# Access Compliance Report

## Public Rights-of-Way

### (Curb Ramps)

Intersection ID: 31853	Main Street: TIBBLE_CREEK_WY	Cross Street: WATERLEAF_LN	Location: SW
ADA ID: 6E6090063DB3	Ramp Type: PerpDiag	Initial Pass/Fail: Fail	Overall Compliance: No
			Severity Score: 21.25

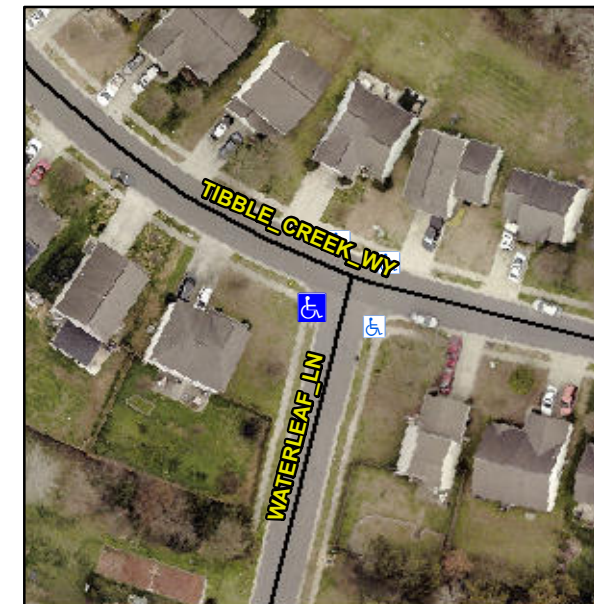
**Not Found, R304.5.1, R304.5.3**

Compliance	Description	Data	Compliance	Description	Data
N/A	Ramp Length (in)	46.0	Yes	Ramp Slope (%)	7.3
No	Ramp Width (in)	47.5	No	Ramp XSlope (%)	6.7
N/A	Flare Type LT	N/A	N/A	Flare Type RT	N/A
N/A	Flare Slope LT (%)	N/A	N/A	Flare Slope RT (%)	N/A
N/A	Flare Traversable LT?	N/A	N/A	Flare Traversable RT?	N/A
N/A	Landing Length (in)	N/A	N/A	DWS Provided?	N/A
N/A	Landing Width (in)	N/A	N/A	DWS Contrast?	N/A
N/A	Landing Slope (%)	N/A	N/A	DWS Length (in)	N/A
N/A	Landing X Slope (%)	N/A	N/A	DWS Full Width?	N/A
N/A	Landing Curb? (Y/N)	N/A	N/A	DWS Offset (in)	N/A
N/A	Shared Landing?	N/A			
N/A	Gutter Ponding?	N/A	N/A	Gutter Slope (%)	N/A
N/A	Gutter Lip Ht (in)	N/A	N/A	Gutter X Slope (%)	N/A
N/A	Painted X Walk1?	No	N/A	Painted X Walk2?	No
	X Walk 1 Direction	To SE		X Walk 2 Direction	To NE
N/A	X Walk 1 Width (in)	N/A	N/A	X Walk 2 Width (in)	N/A
	X Walk 1 Slope (%)	2.4		X Walk 2 Slope (%)	3.0
	X Walk 1 X Slope (%)	2.2		X Walk 2 X Slope (%)	3.4

**Remove & Replace Curb Ramp With Two New Directional Ramps or Equivalent.**
